**SUBJECT : Hyundai ImageQuest Co., Ltd.  
FCC ID: PJIL19C0D072  
FCC Part 15 Subpart B Certification**

**FCC ID : PJIL19C0D072  
Model No. / Type No.: Q19 / L19C0D072**

## •Solution for EMI

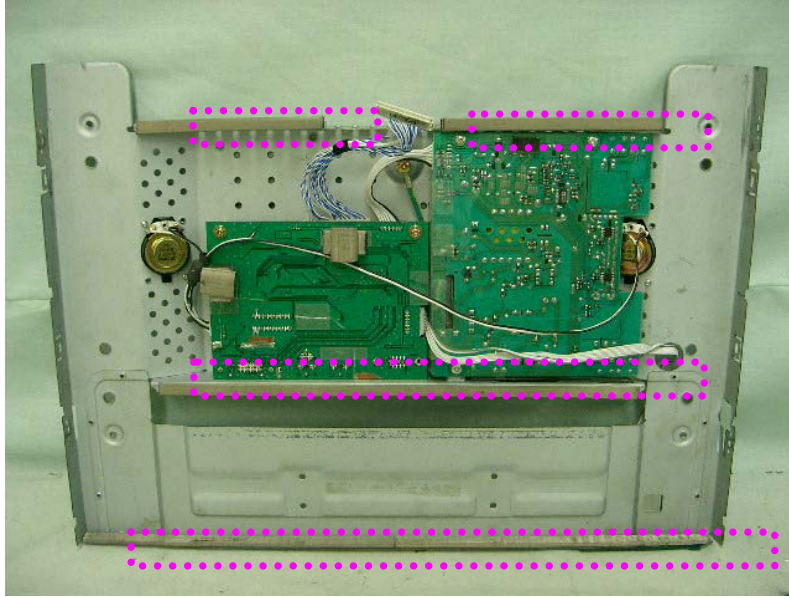
**1. Attach a gasket to internal frame**

**2. Apply a ferrite Core to the Speaker Cable**

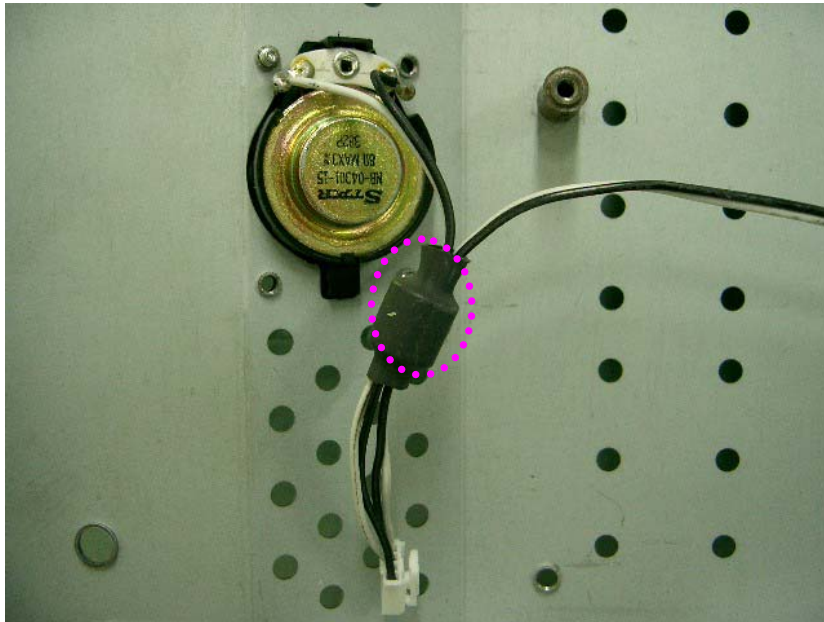
**3. Attach a gasket to main board**

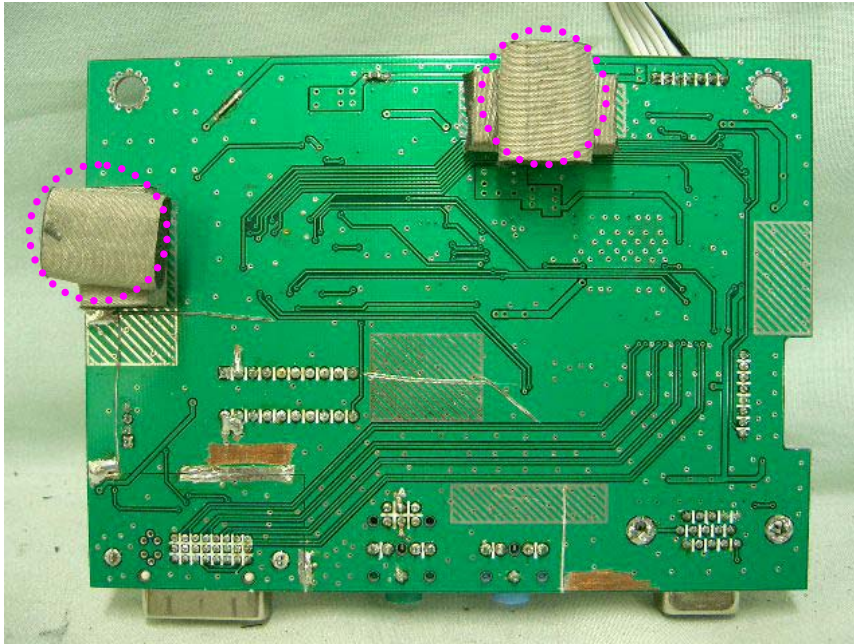
**4. Apply a strip of aluminum tape on the conductive strip to the frame.**
